Project Name  
**18\_FRYER STREET**

Site Address  
**18 FRYER STREET, QUEENSTOWN**

This email is a request under s92(1) of the Resource Management Act 1991 (RMA) for further information to assist Council in processing your application and understanding of the actual or potential adverse effects of your proposal. Please see the below which sets out why the request is being made, and process should you refuse to provide information or not respond to this request.

2 3D View - North East corner  
SCALE

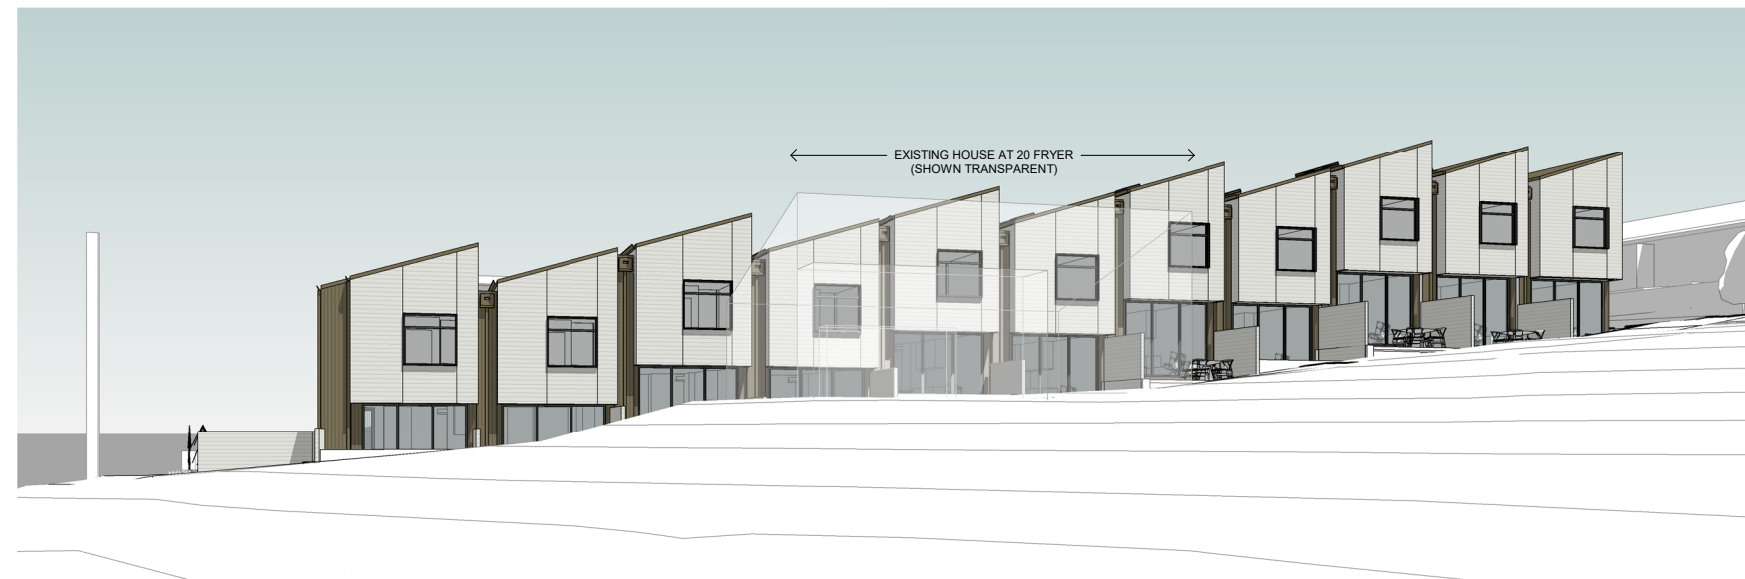
ODP Provision	Comment
<i>“cookie cutter” design solutions and flat, blank or uninteresting walls; and</i>	façade, the repetitive nature of the development covering a long building form of circa 45m (considerably longer than the 30m maximum in Rule 7.5.5.2vii) results in a cookie cutter design that dominates the site and creates a sense of higher apparent density from adjoining properties and the public realm. The dominant nature of the continuous building footprint contributes to a sense of being ‘closed in’ notwithstanding there are no direct windows looking south into the adjoining living spaces of development at 14 Fryer Steet.
<i>(iii) Attractive use of landscaping materials to enhance building appearance and use.</i>

ODP Provision	Comment
<i>(i) Environmentally sustainable and responsive design solutions that include attention to energy efficiency, waste disposal, transportation access, sunlight, and outdoor spaces;</i>	<p>The proposed development is orientated to provide good solar access to the units and outdoor living areas on the north side of the site, while also providing reasonable levels of sunlight to adjoining developments by generally meeting the height and bulk and location standards. The size of the outdoor living areas although not meeting the minimum 20m<sup>2</sup> standard, do provide for a quality north facing outdoor living area with direct access from the open plan living floor. The outdoor living areas are considered adequate for visitor accommodation or residential use of the units.</p> <p>The development is well located in terms of walkable urbanism with a wide range of activities including a supermarket and public transport options available within a 10 minute walk.</p> <p>The proposed development has a poor relationship with the public realm in that it has no ‘informal surveillance’ or overlooking of the street from the front unit and therefore does not meet a basic tenant of good urban design and CPTED (Crime Prevention through environmental design). This could be rectified by adding additional windows that allow informal overlooking of the street from the front unit. One option for additional windows is suggested below (circles red) but this is only one suggestion as to how informal surveillance of the street may be achieved.</p>

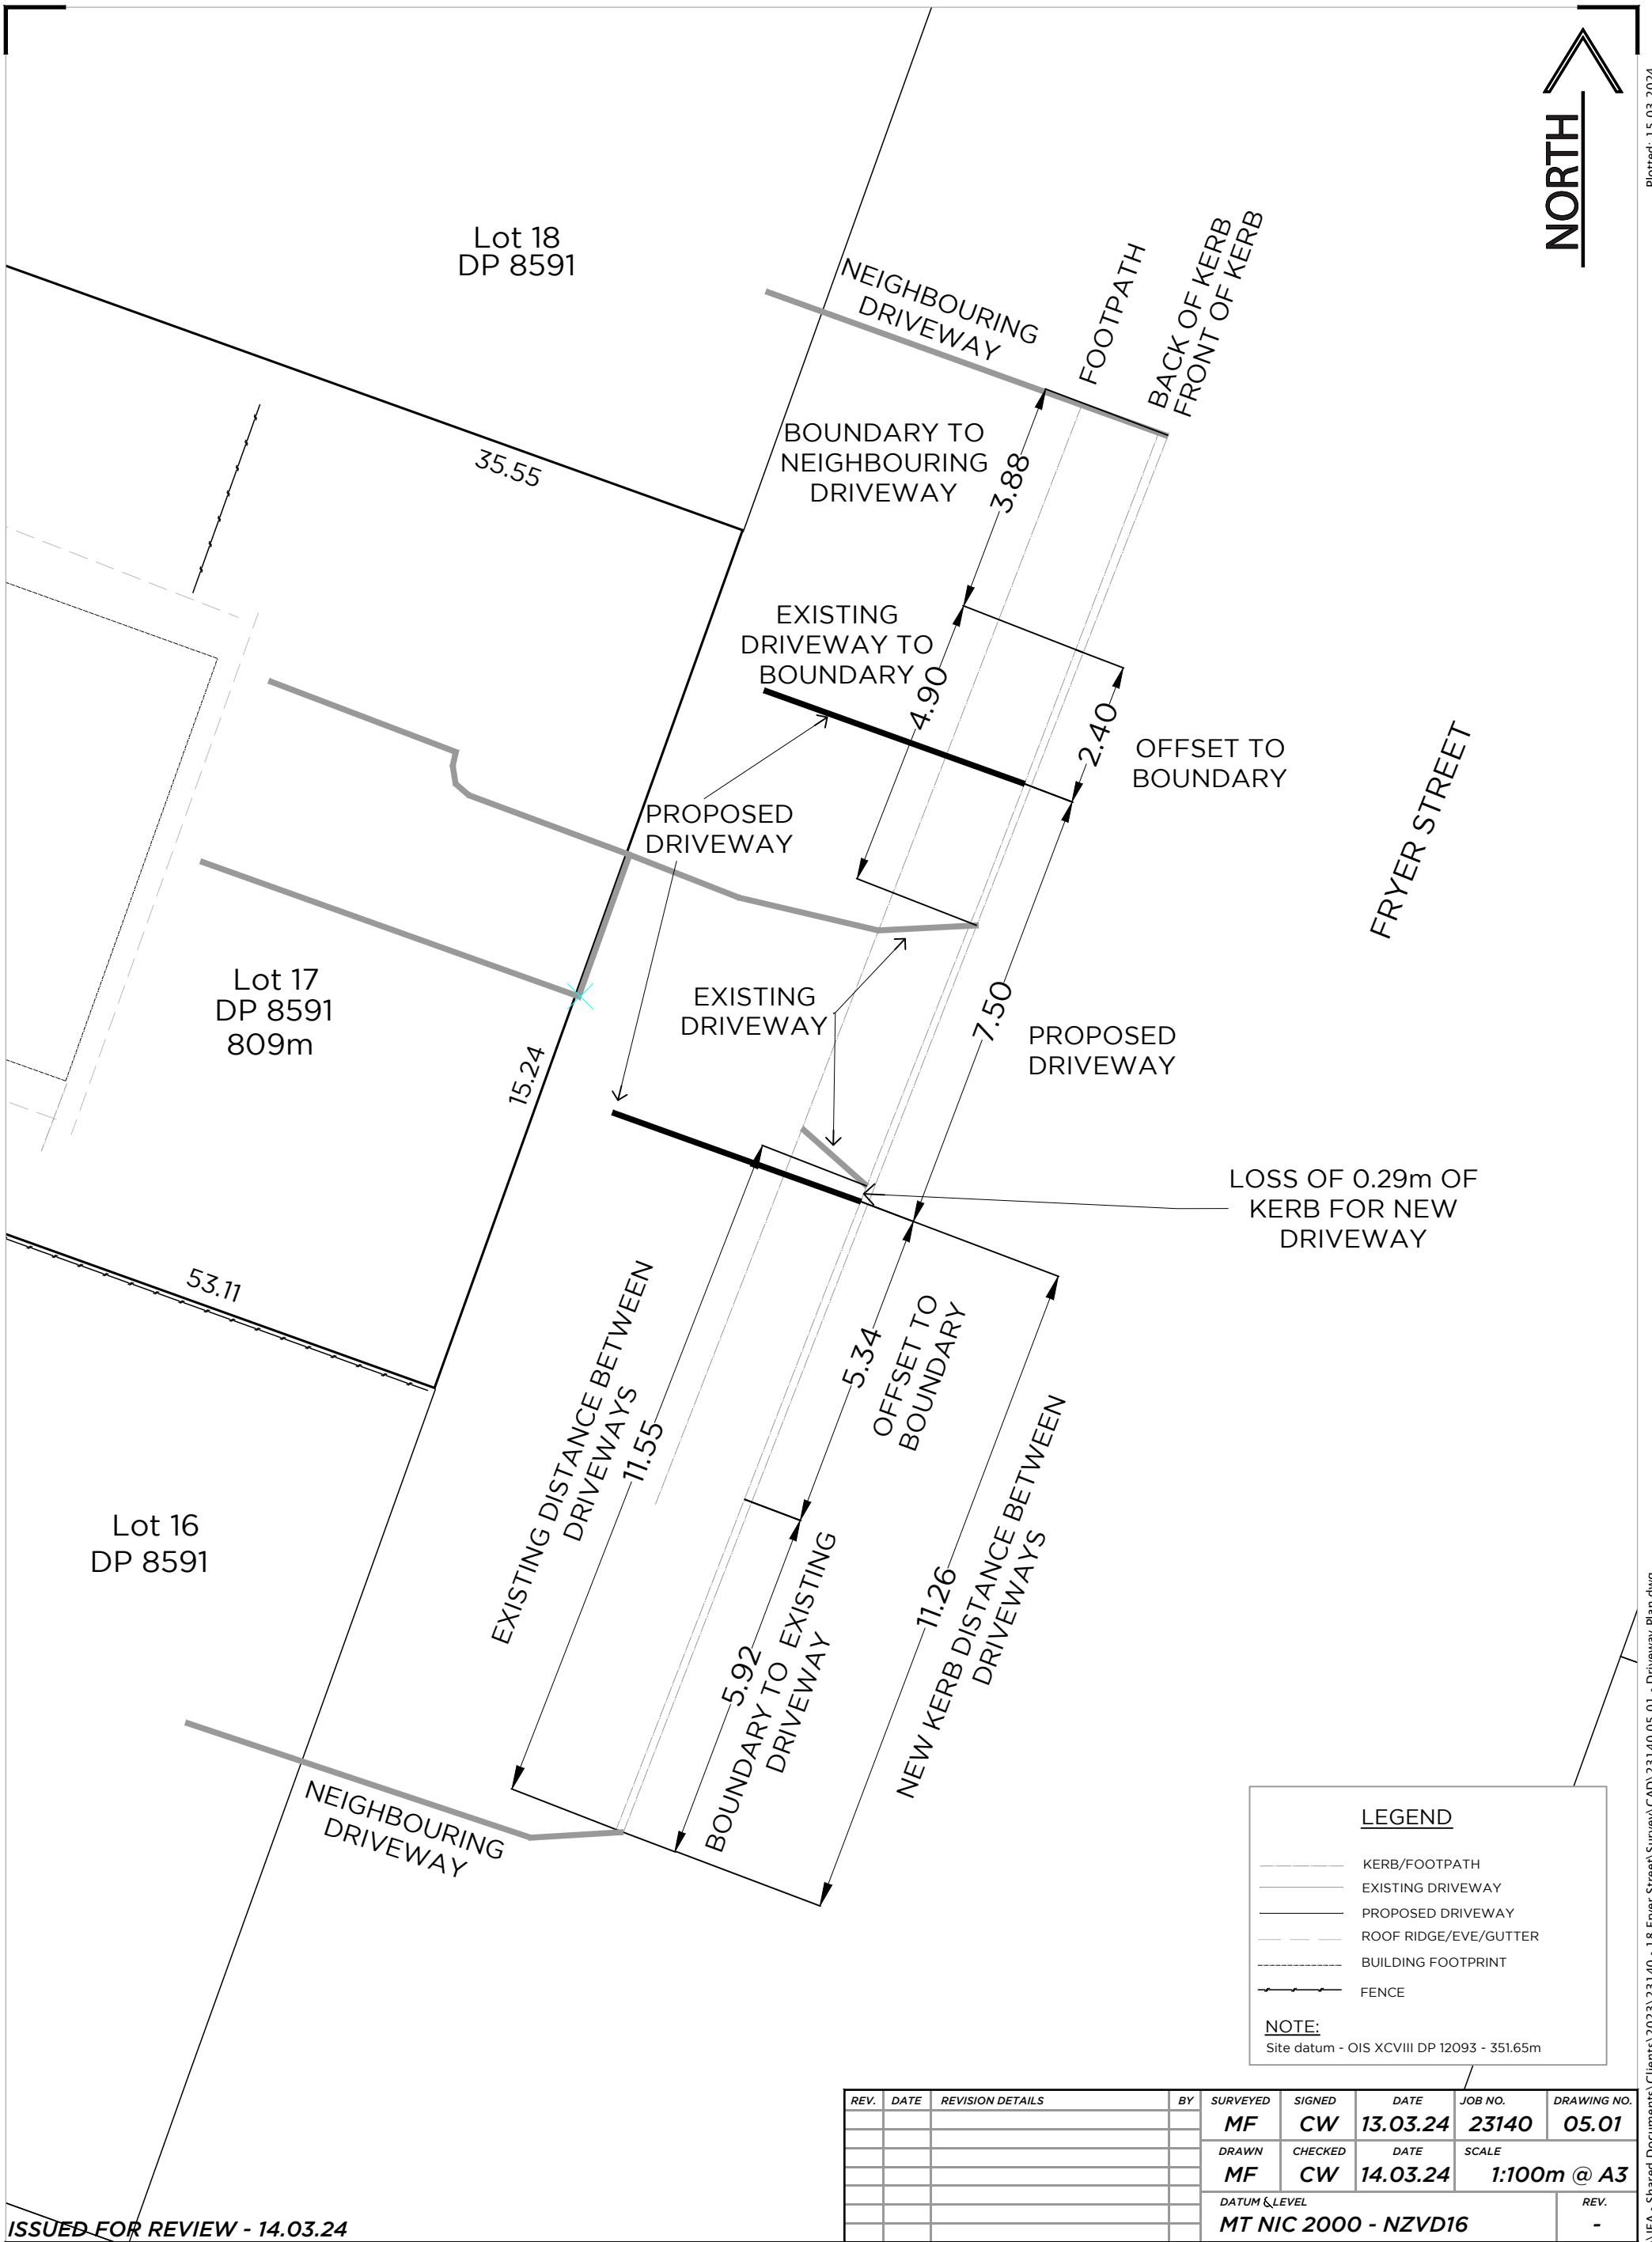
Starting with the front yard area of the development a number of improvements have been made to address the concerns raised. In particular this includes reducing the number of carparks to 3 spaces (1 accessible) which provides an opportunity for a large planter area on the northern boundary, which includes the planting of 3 specimen trees. This reduces the overall length of the vehicle crossing to 7.5m and combined with the additional windows on the front unit, along with improvements to the landscaping will result in a substantially improved presentation to the street and overall neighbourhood amenity.

The reconfigured bin storage area will enable access from the accessible carpark while also creating the opportunity to plant in front of the screen wall with a creeper which, combined with the southern landscape and letterbox fencing creates a clear pedestrian entrance to the development.

In terms of breaking up the building length and massing, a number of changes are proposed including; an updated colour scheme that creates an alternating pairing of units between light and dark colours (except for the front unit which is not paired due to the odd number of units) and the reduction in size of Unit 6 which creates opportunity for additional landscaping and further variation to the articulation of the building mass.

The changes to Unit 6 relate to the southern elevation, which is both the side of pedestrian access to the whole development but is also the elevation that the recently built units at 14 Frayer Street look directly towards. The proposed break to the repetition of the building length along with the proposed landscaping will improve the overall appearance of the development and also improves the pedestrian amenity to the site and helps to break up the overall massing of the development.

On balance, as a result of the proposed changes, I am now in a position to support the proposal from an Urban Design perspective.
